UNITED STATES  
DEPARTMENT OF THE INTERIOR  
BUREAU OF LAND MANAGEMENTNew Mexico Oil Conservation Division, District I  
1625 N. French Drive  
Hobbs, NM 88240FORM APPROVED  
OMB No. 1004-0137  
Expires July 31, 2010**SUNDRY NOTICES AND REPORTS ON WELLS**  
**Do not use this form for proposals to drill or to re-enter an abandoned well. Use Form 3160-3 (APD) for such proposals.**

West Cap Queen Sand Unit #1

Request 1 yr temporary abandoned status. Subject well is in a part of Caprock Queen field with little injection support & as a consequence would have little utility as a producer at this time. However, the well has potential as a producing well in the event a C02 pilot project on the Rock Queen Unit to the North is successful & the project is expanded field wide.

**APPROVED FOR 3 MONTH PERIOD**  
**ENDING JAN 25 2012**

FIELD: Caprock  
LEASE/UNIT: West Cap Queen Sand Unit  
COUNTY: Chaves

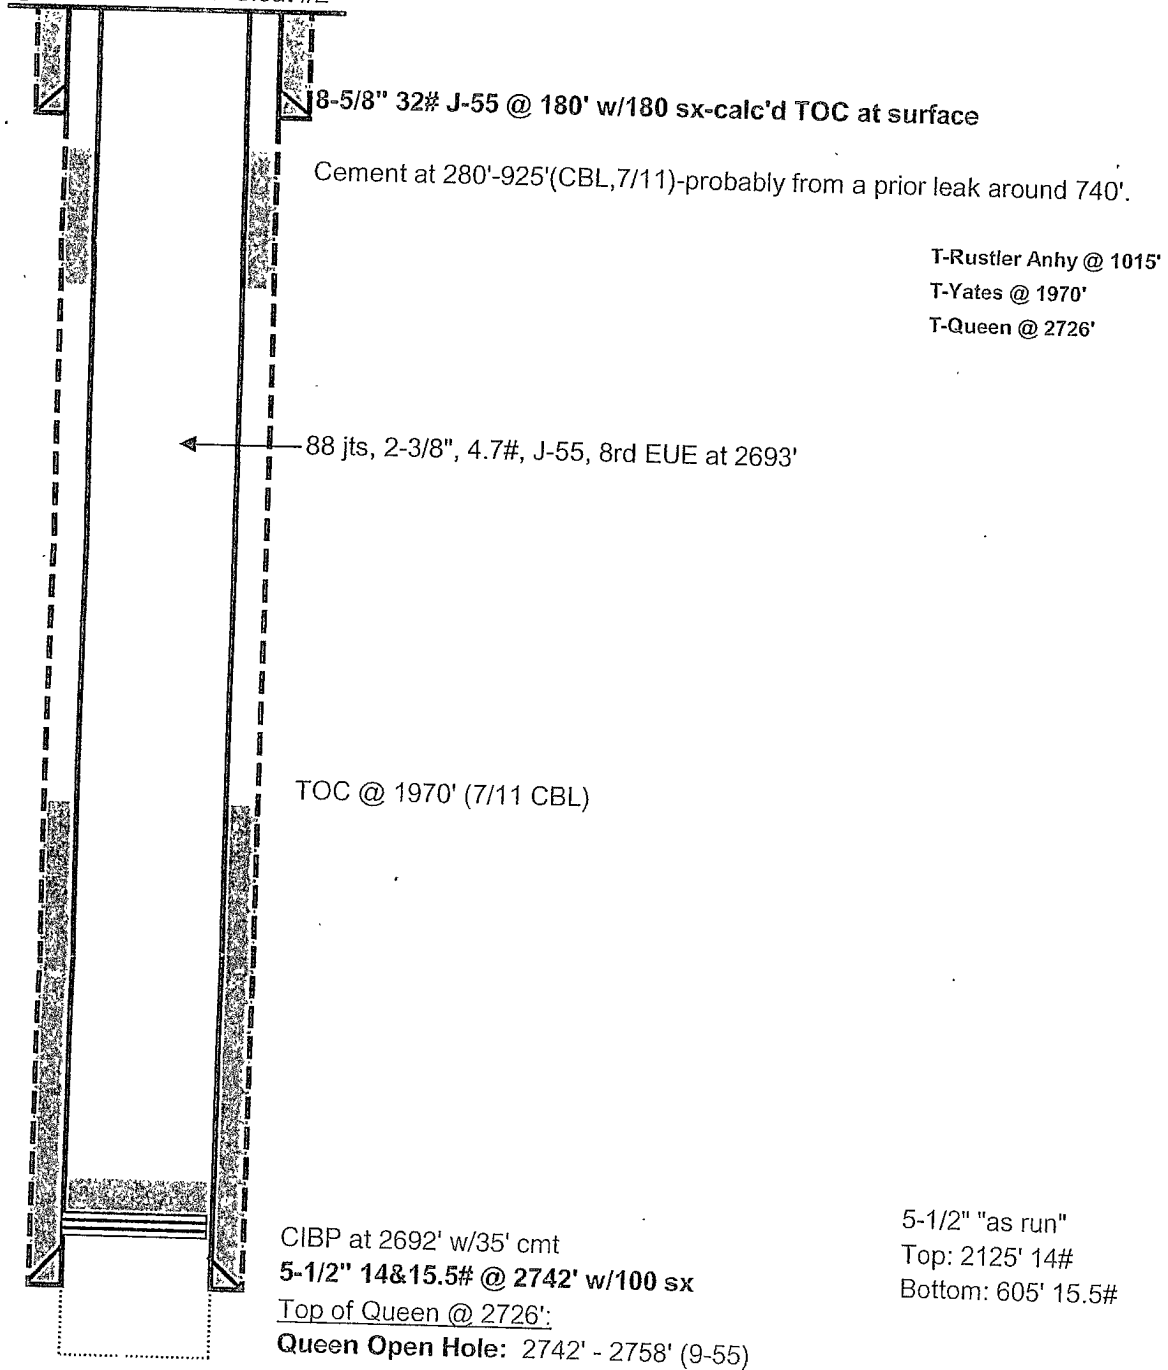
1. POOH w/ production equipment.

2. RIH w/ CIBP &amp; set @ 2692'. Dump bail 35' of cmt on CIBP.

3. RIH w/ tbg &amp; circulate hole with FW pkr fluid. POOH w/ tubing &amp; perform MIT.

- A. A bridge plug or packer must be installed as close to 50 feet above any open perforations or open hole as possible. If a cement plug is used, the top of the cement must be verified by tagging.

- B. The wellbore must be filled with corrosion inhibited fluid and pressure tested to 500 psi. The casing shall be capable of holding this pressure for at least 30 minutes with a 10% allowable leakoff.
